**TOWNSHIP OF NORTH BRUNSWICK**

**MEMORANDUM**

**SUBJECT:** Block: 227 Lot: 3.13  
Street Address: 17 Peppermint Hill Road  
Applicant: Mr. Sanjay Bharadwaj

ARCHITECTURAL SITE  
PLAN

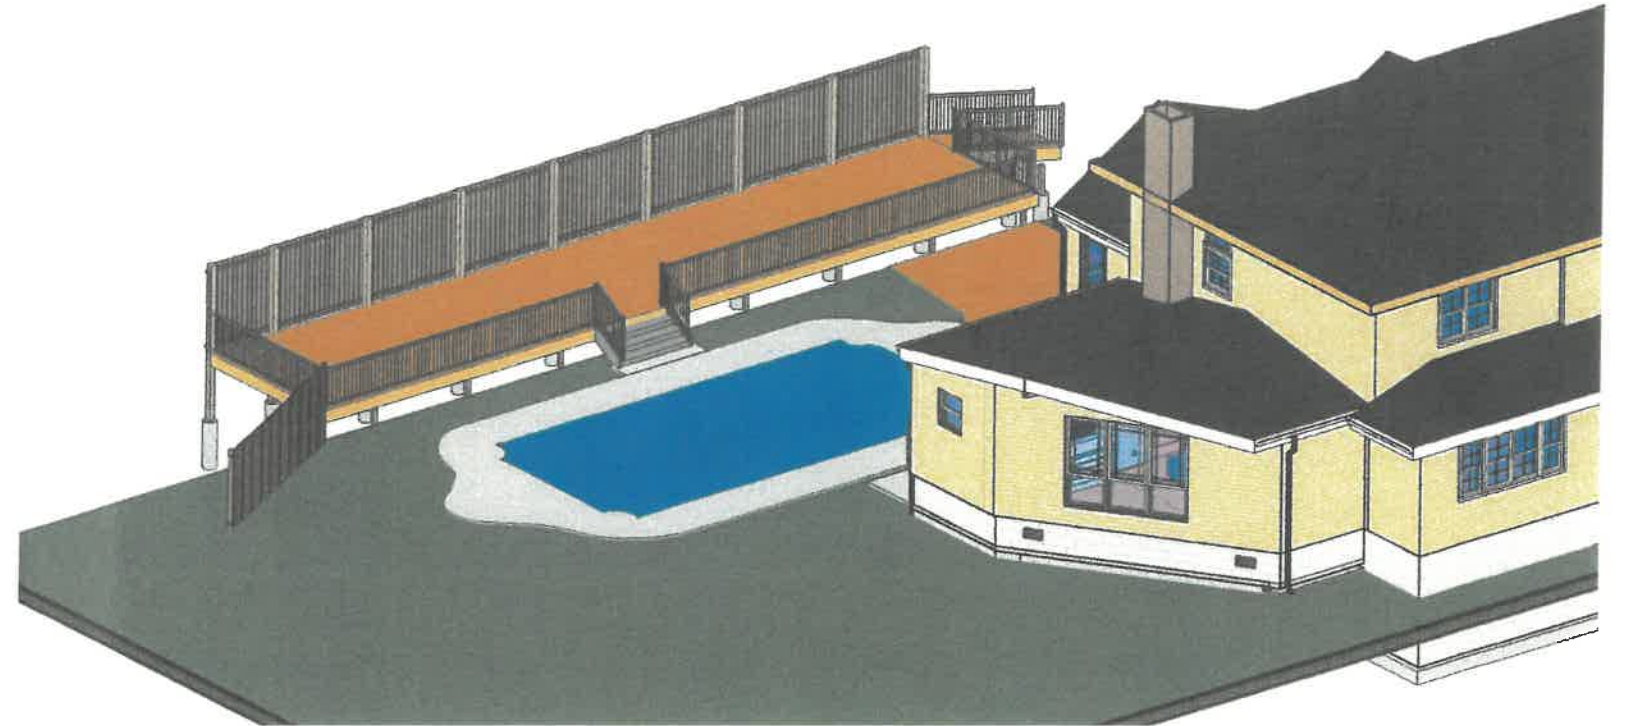
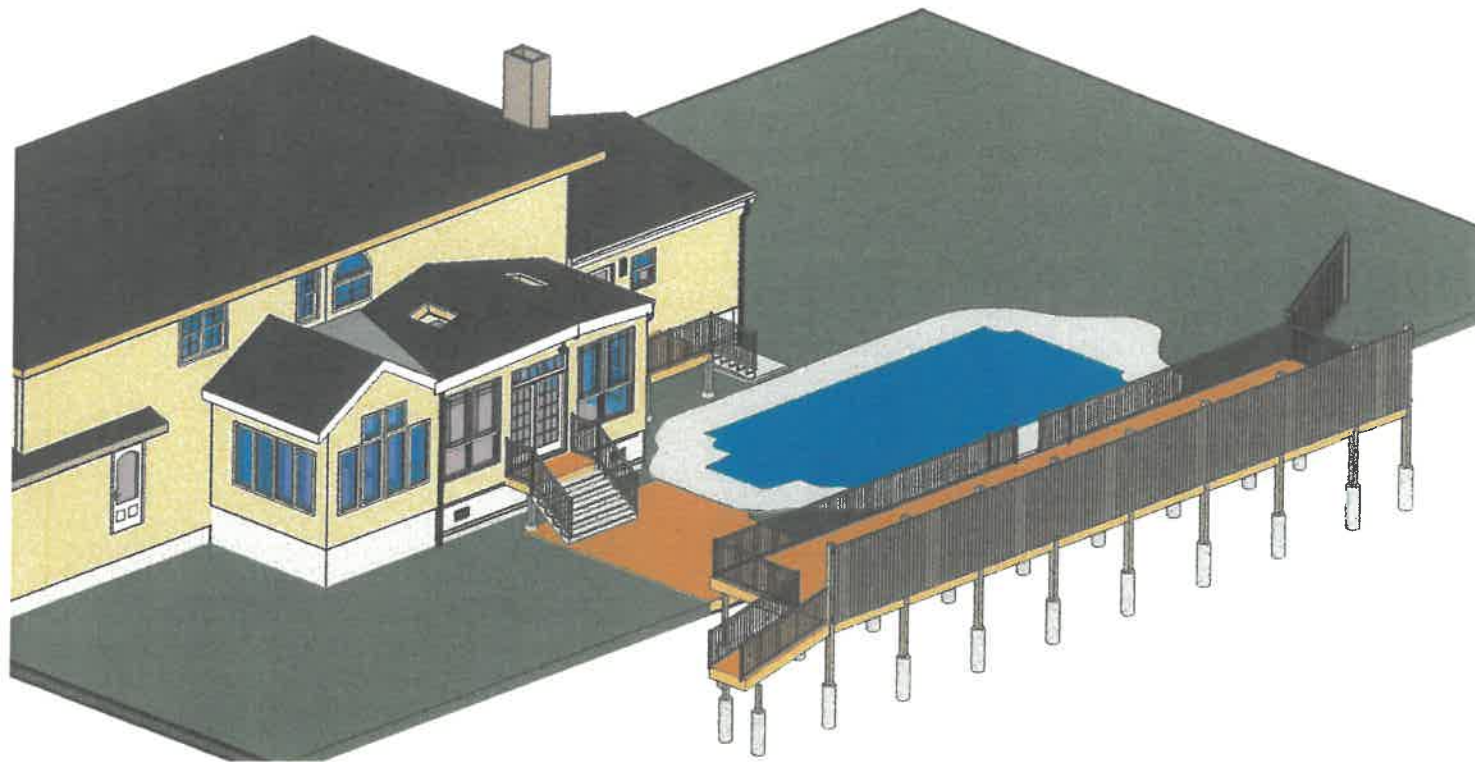
- a. **Rear Yard Setback, New “Detached” Deck** – The applicant proposes to construct a new 791 sq. ft. detached deck in which one corner is located 3 ft. from the rear property line, and another corner is located 7 ft. from the rear property line. The different or uneven rear yard setback distances are due to the fact that the house is not parallel to the rear property line. The rear yard setback for accessory buildings and structures is five (5) feet in the R-2 Zone.

- b. **Side and Rear Yard, Existing Shed** – The applicant wants to legitimize an existing 150 sq. ft. shed which encroaches into both the rear and side yard setbacks. The shed is approximately 2’3” from the rear property line and 3’2” from the side property line where a five (5) ft. setback from the side and rear is required for an accessory structure.

- c. **Rear Yard Setback, Existing “Detached” Deck** – The applicant wishes to legitimize an existing 170 sq. ft. deck which encroaches into the rear yard setback. The existing deck is approximately 1’6” from the rear property line where the rear yard setback is five (5) feet for accessory buildings and structures.

Applicant should justify the setback variance and provide testimony to satisfy the C-1 (hardship) and/or C-2 variance criteria.
